UNITED STATES PATENT AND TRADEMARK OFFICE

Office Action Summary	Application No. 10/786,688	Applicant(s) ZINSMEYER ET AL.	
	Examiner Theresa Trieu	Art Unit 3748

DETAILED ACTION

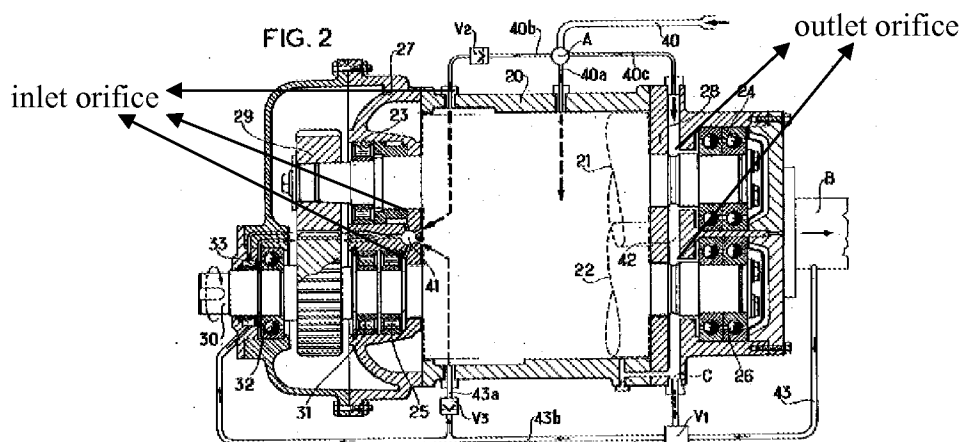
With regard to applicants' argument that Libis '440 does not disclose/suggest orifices at each of the inlet and outlet bearing that includes a smaller slow area than the flow passage (see Remarks section, page 6, lines 18-19). The examiner respectfully disagrees with this position.

Libis teaches that each of the choke orifice, the inlet orifice and the outlet orifice is substantially smaller than any portion of said primary passage (see Fig. 2 and note below) [emphasis added].
